BEFORE THE MERIDIAN CITY COUNCIL

**CASE NO. FP-2024-0010
ORDER OF CONDITIONAL
APPROVAL OF FINAL PLAT**

STAFF REPORT COMMUNITY DEVELOPMENT DEPARTMENT

DATE: 7/9/2024
TO: City Council
FROM: Sonya Allen, Associate Planner
208-884-5533
SUBJECT: FP-2024-0010
TM Creek No. 7
PROPERTY LOCATION:
153 S. Benchmark Way, in the northern
½ of Section 14, T.3N., R.1W.

B. Final Plat (dated: 4/18/24)

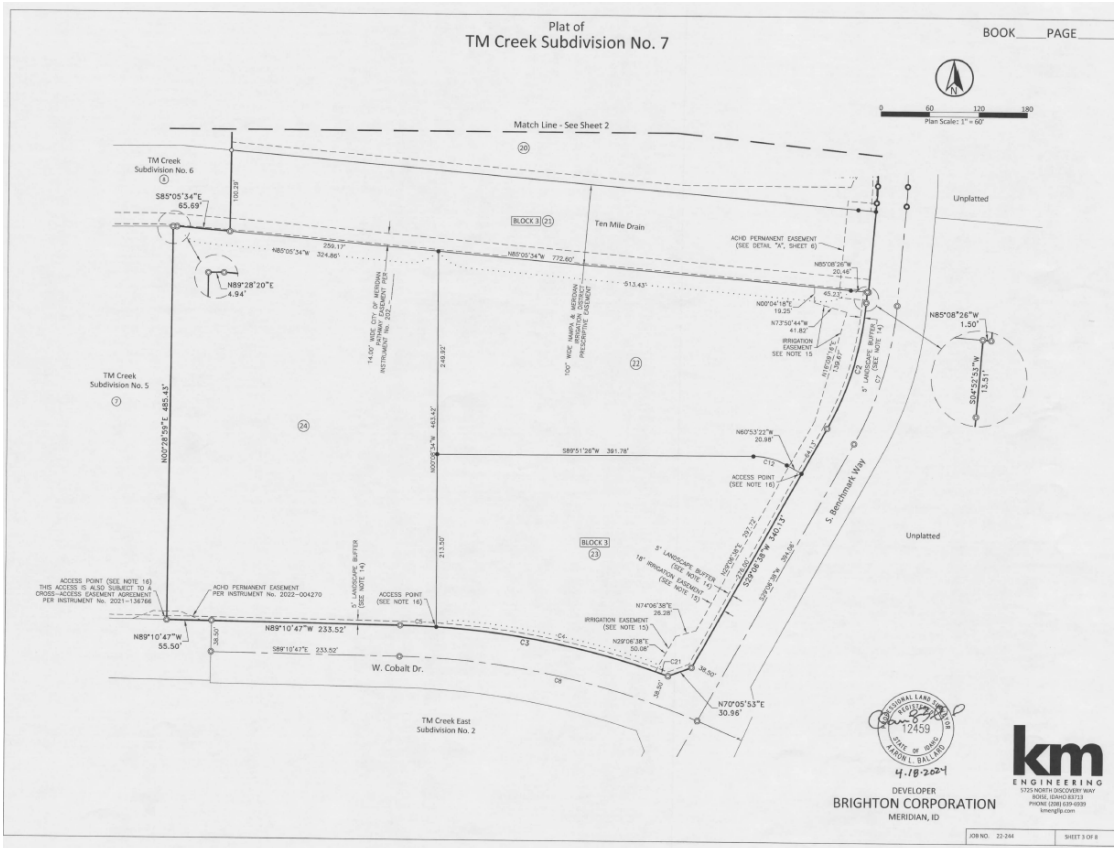
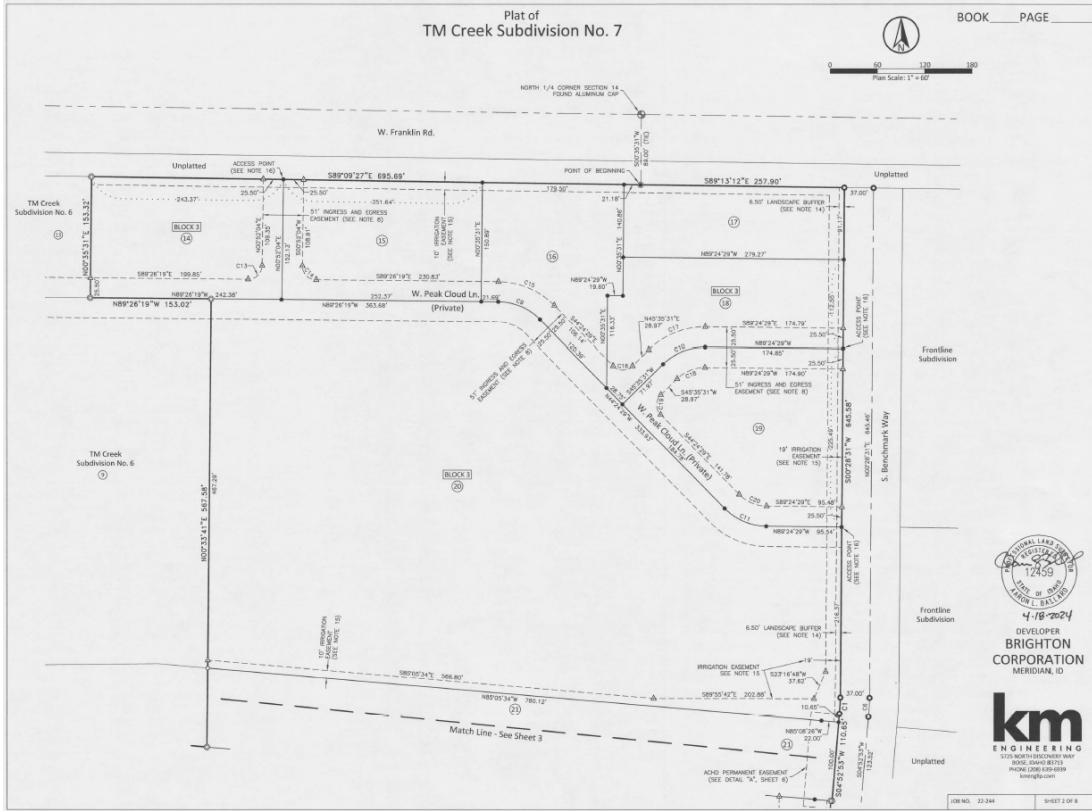
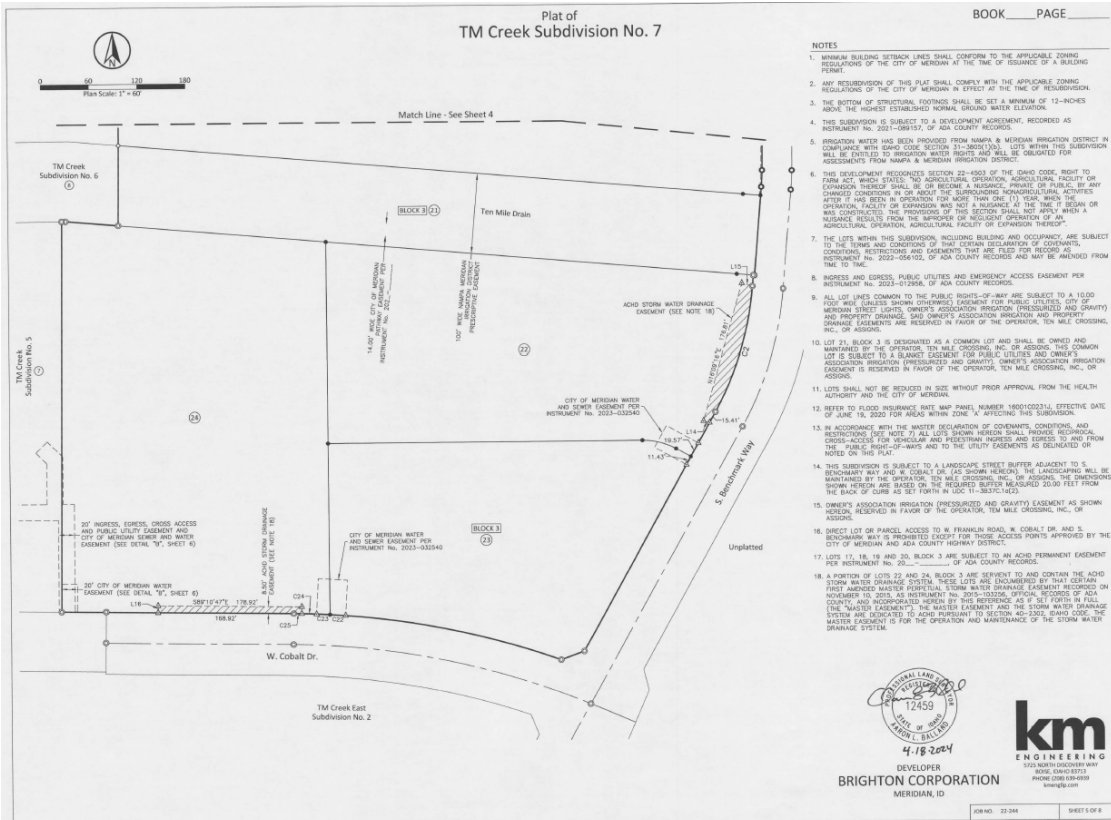
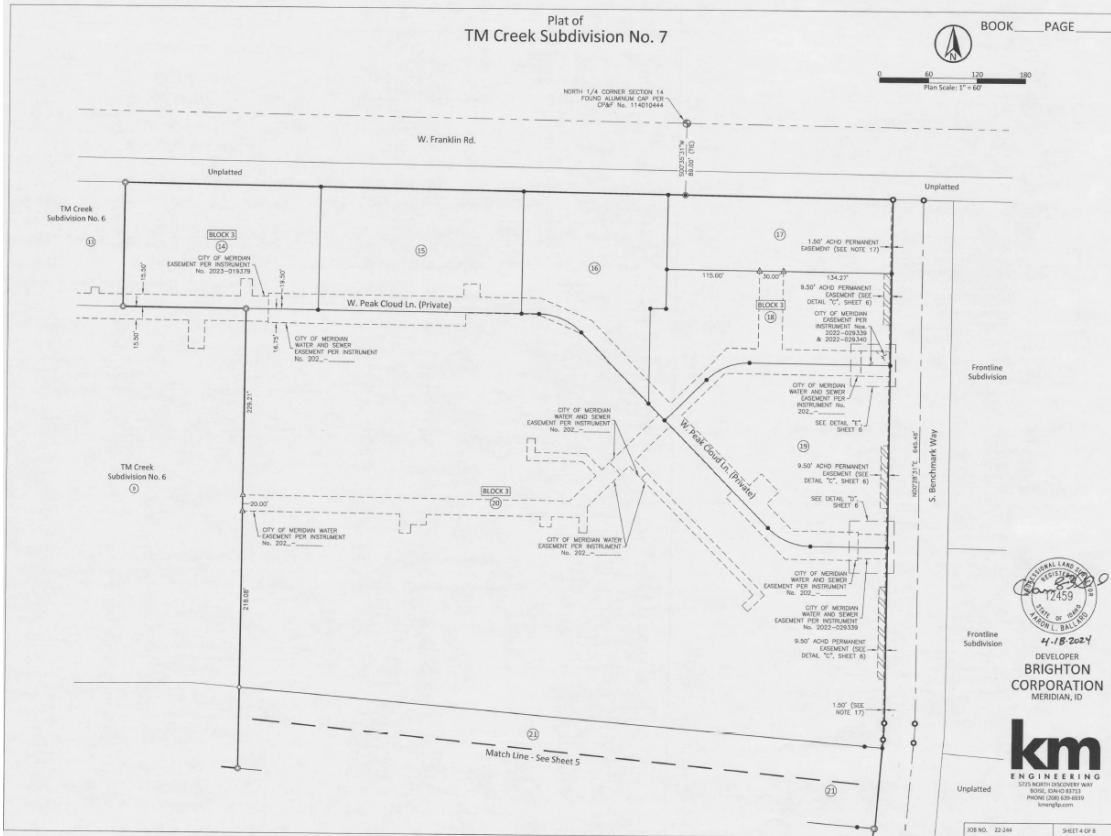
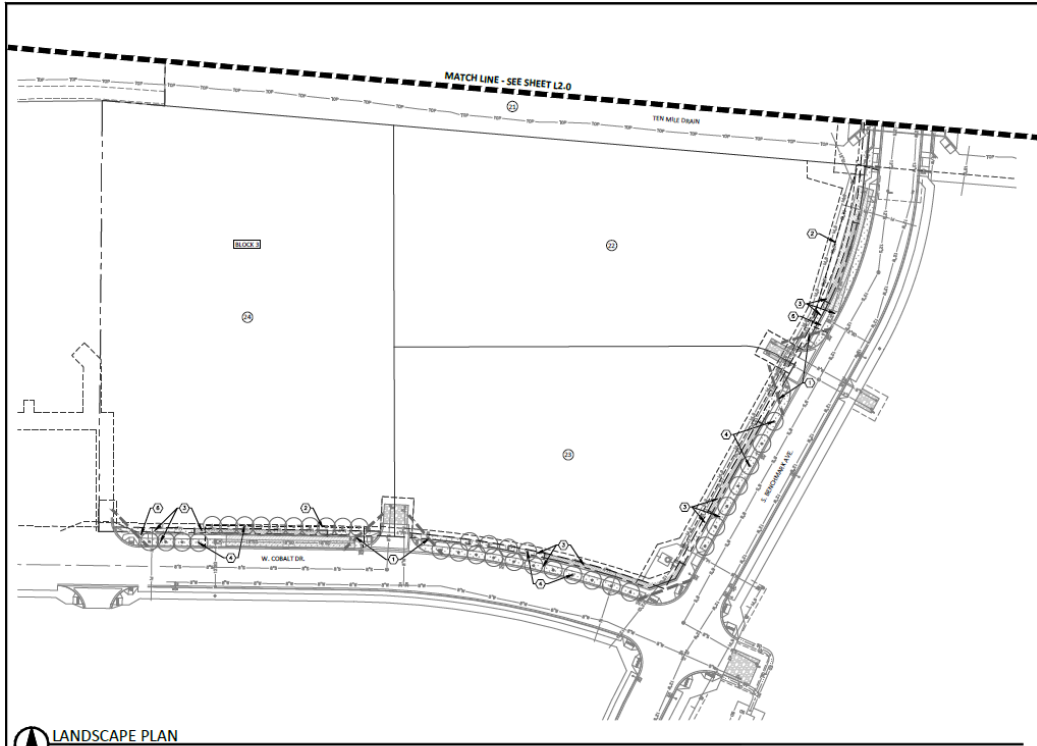
3. Prior to submittal for the City Engineer's signature, have the Certificate of Owners and the accompanying acknowledgement signed and notarized.
4. The final plat prepared by KM Engineering, stamped on 4/18/24 by Aaron L. Ballard, included in Exhibit B shall be revised as follows:

- a. Note #17: Include the recorded instrument number of the ACHD permanent easement.
 - b. A cross-access/ingress-egress easement shall be granted via a note on the plat or a separate recorded agreement between all non-residential lots in accord with UDC 11-3A-3A.2 and preliminary plat condition #2j.

- c. Include the recorded instrument number of the 14' wide City of Meridian pathway easement graphically depicted on the plat on Sheet 5.
 - d. Include the recorded instrument number of the City of Meridian water and sewer easement graphically depicted on the plat on Sheet 4.

- e. Include the recorded instrument number of the City of Meridian water easement graphically depicted on the plat on Sheet 4.
 - f. Include the number of the C-N 1/16 corner section 14 found aluminum cap per CP&F No. 202_ - _____ on Sheet 1.

- g. In the References notes on Sheet 1, include the book and page numbers of TM Center East Subdivision No. 2.
5. The landscape plan prepared by KM Engineering, dated 4/18/24 included in Exhibit C, shall be revised as follows:
